TITLE: **DETAILS AT LADDER**

DES: MKW		DR: NAB	APPROVED:
CHK: CWS		CHK: CAJ	
State Proj. No. 118-080-040			
Sheet No. ADD 1 of 1 Sheets

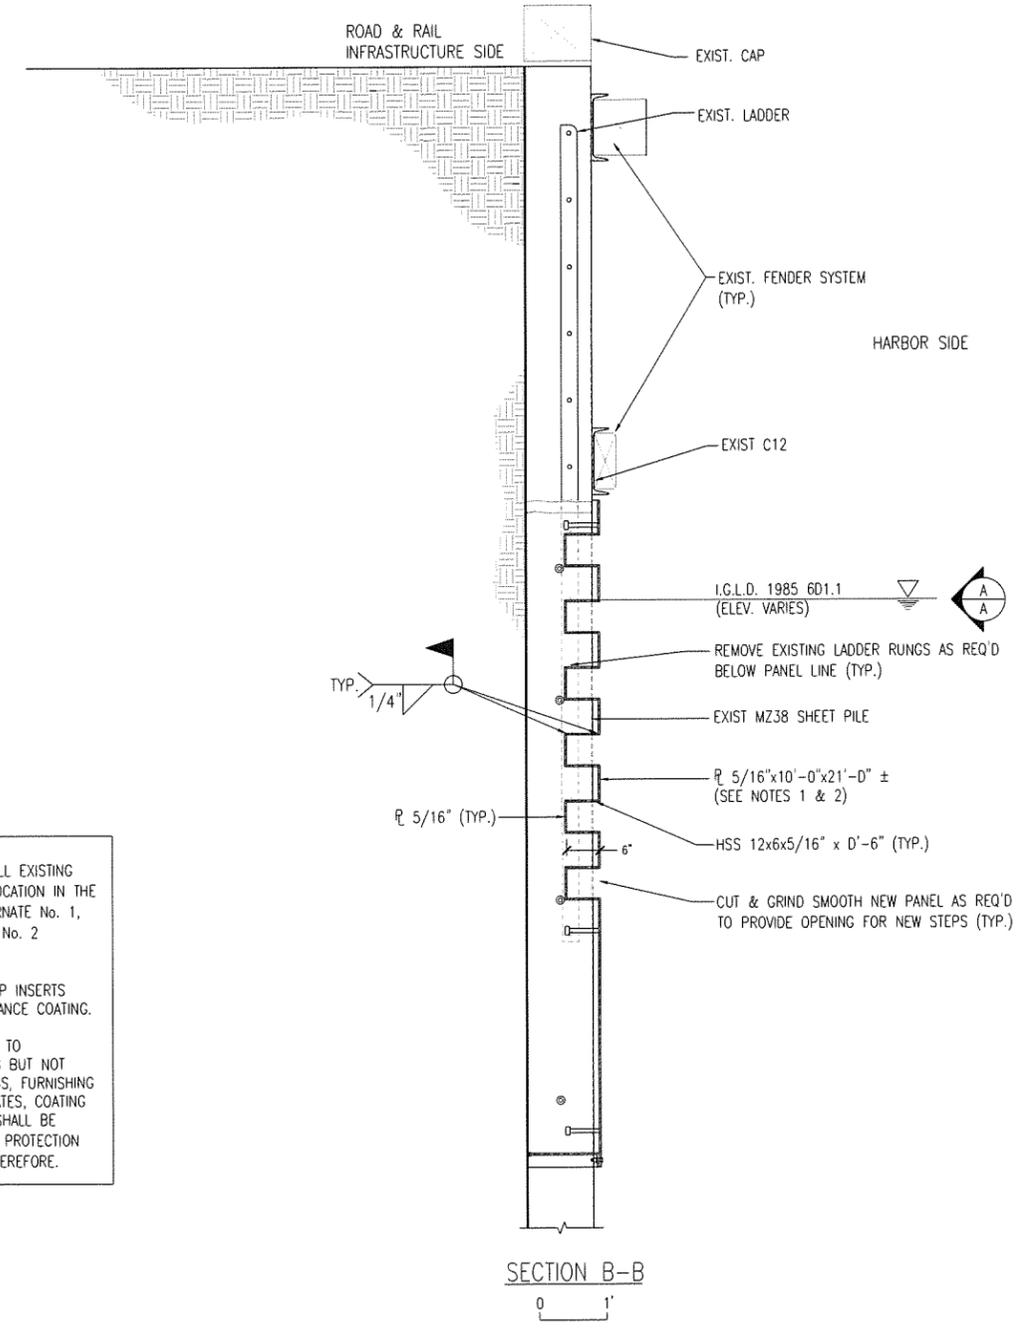
PROVIDE @ (11) LOCATIONS (TYP.)

- I.C.L.D. 1985 6D1.1' (ELEV. VARIES)
- REMOVE EXISTING LADDER RUNGS AS REQ'D BELOW PANEL LINE (TYP.)
- HSS 12x6x5/16" x D'-6" (TYP.)
- CUT & GRIND SMOOTH NEW PANEL AS REQ'D TO PROVIDE OPENING FOR NEW STEPS (TYP.)

**NOTE:**  
 - THIS DETAIL WILL BE REQUIRED AT ALL EXISTING LADDER LOCATIONS. THERE ARE (8) LOCATION IN THE BASE BID, (0) LOCATIONS IN ADD ALTERNATE No. 1, AND (3) LOCATIONS IN ADD ALTERNATE No. 2 RESULTING IN (11) TOTAL LOCATIONS  
 - ALL OUTSIDE SURFACES OF NEW STEP INSERTS SHALL BE COATED WITH HIGH PERFORMANCE COATING.  
 - PAYMENT FOR ALL WORK NECESSARY TO CONSTRUCT THE NEW STEPS, INCLUDING BUT NOT LIMITED TO REMOVAL OF EXISTING RUNGS, FURNISHING AND INSTALLING OF HSS 12x6 AND PLATES, COATING WORK AND COATING TOUCH UP WORK SHALL BE INCLUDED INCIDENTAL TO ITEM "INSTALL PROTECTION PLATE" WITH NO SEPARATE PAYMENT THEREFORE.
